Subject: Bingham Residence – Plan Review Comments

Kimball Engineering has completed the first review of the proposed Bingham Residence (Lot 77 of Powder Mt. Resort) located at Weber Co., Utah. This proposed project consists of an approximately 5,185 square foot home, not including the attached garage. This review was based upon the following:

Project Name: Bingham Residence

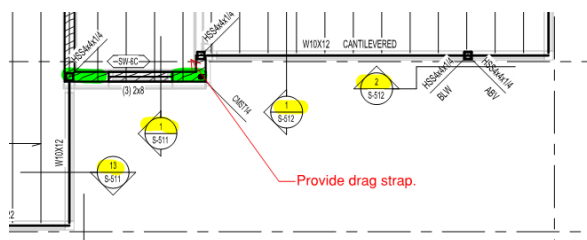
- S1. Sheet S-101: There is a hold down missing at gridline 3.
